Diversified Building
Solutions, LLC.

Re: Groundwater Remediation
2013/2014 Action Plan Modifications
Case No. 1987-2534-KE
Chester River Hospital Center
100 Brown Street, Chestertown
Kent County, Maryland
Facility ID No. 3168
Project No: 14004.00

RE: GROUNDWATER REMEDIATION 2013 ACTION PLAN APPROVAL

RE: RESPONSES TO QUESTIONS
Case No. 1987-2534-KE
Chester River Hospital Center
100 Brown Street, Chestertown
Kent County, Maryland
Facility I.D. No. 3168

Appendix 3
Map of Proposed Injection/Extraction Wells

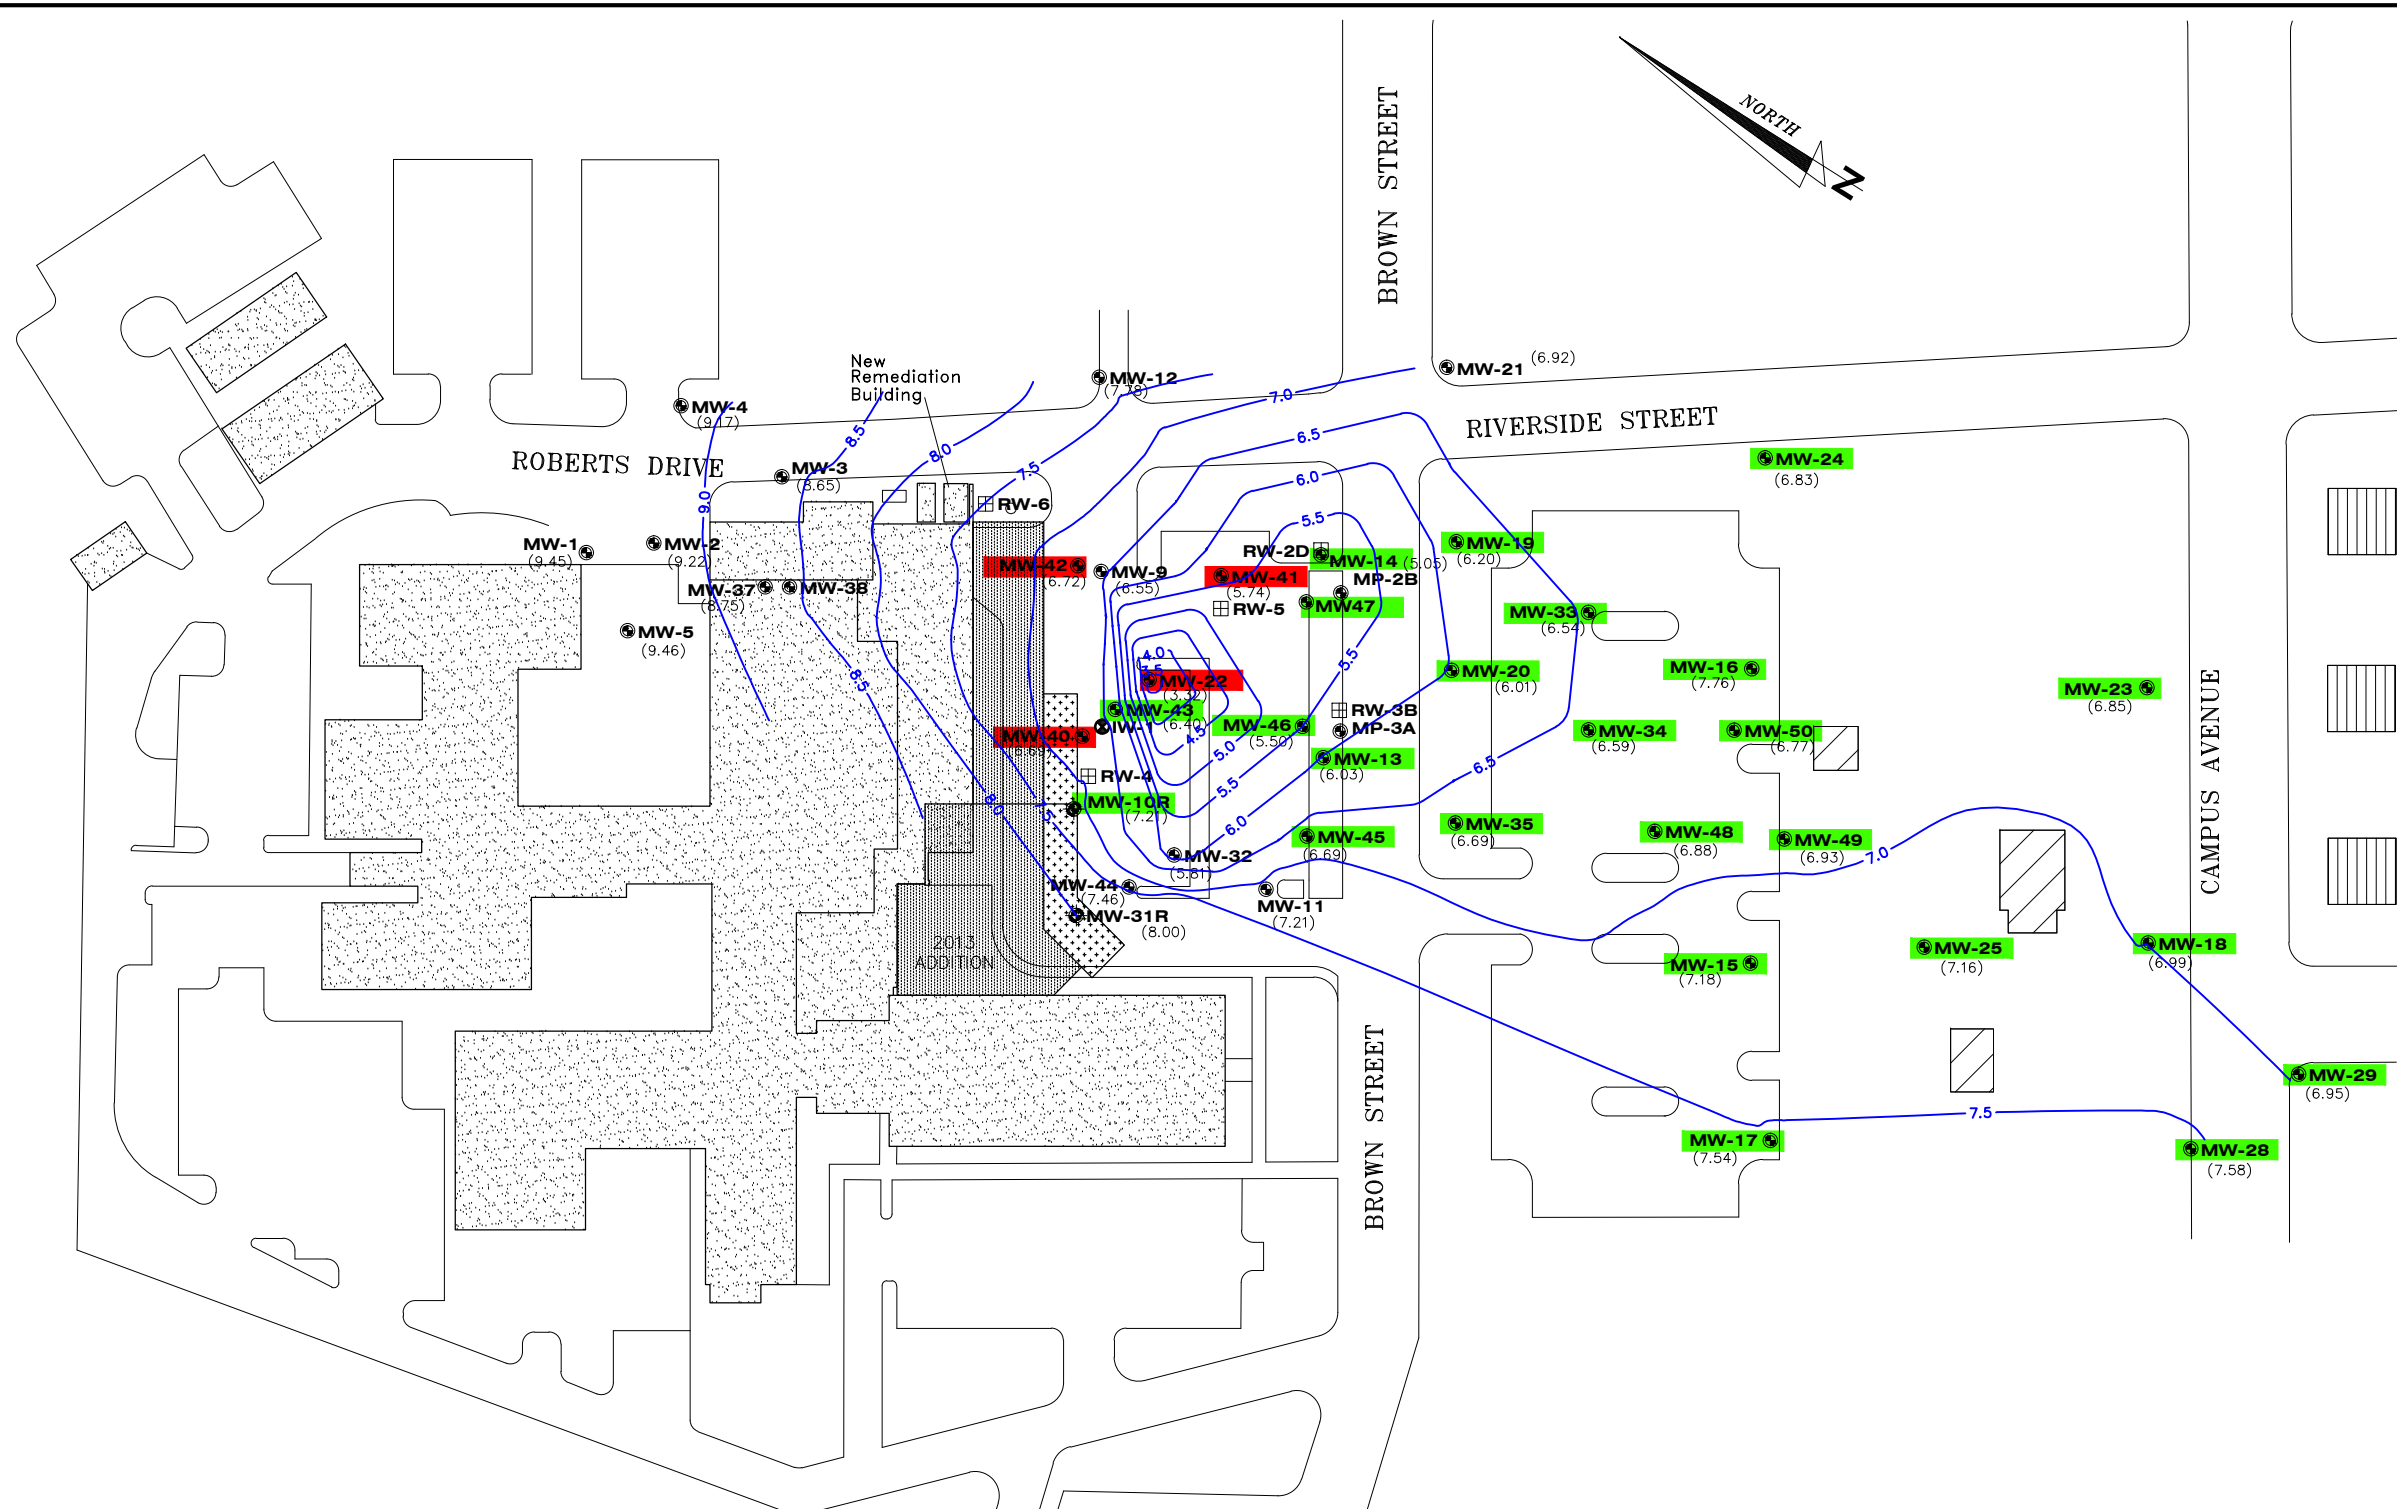
At the meetings with the Town on April 15th and April 21st, Mr. Bob Sipes and/or Mr. Mark Eisner raised questions as to whether or not MW-10R and MW-13 were in fact within the area of hydraulic control of the remediation system. As follow-up to address this particular concern and to be able to learn more about Ivey-sol®, the push-pull process, and other questions concerning the proposed pilot scale study, CRHC authorized Mr. Ivey to speak one-on-one with Mr. Sipes and Mr. Eisner to further address any concerns they may have in these regards. Mr. Ivey provided significant information which was further considered by the Town in their deliberations on this matter.

The implementation will be limited to the area defined by wells RW6, RW2D, MW13, and MW10R. Injection in this area will ensure that any potential LPH or high dissolved phase concentrations that are mobilized would be within the known capture zone of the remediation system. This allows for the Department to gain confidence in CRHC's implementation of the proposed corrective action while maintaining a level of protection from the hydraulic control of the pump and treat system.

7. **Limits on Extensiveness of Pilot Testing**- The Town seeks a clear commitment that the revised pilot testing work plan reflect four (or fewer) wells for pilot testing and not the six as first proposed. Those directly upgradient of the present locus of the pump-and-treat cone-of-depression seem more appropriate test injection locations than do wells of more of a cross-gradient position. The revised work plan should reflect or otherwise address this concern.

Additionally, following these meetings CRHC's team has further reviewed the hydrogeological data. Following the review the team is confident that MW-10R and MW-13 are within the hydraulic control of the remediation system. The team; however, has agreed to **remove** MW-10R and MW-13 as injection/extraction wells from the pilot study of the push-pull application. CRHC and its team of consultants believe this change would satisfy **all concerns** raised by the Town and its consultant in these regards. We have further modified the well locations to include MW-22, MW-40, MW-41, and MW-42. This will ensure the continuation of pump and treat operation during the push-pull application. All wells have the well screens above the high water table. We are attaching a revised map showing the proposed injection/extraction wells in Appendix 3 as well as the identification of the well screen elevations relative to the water table.
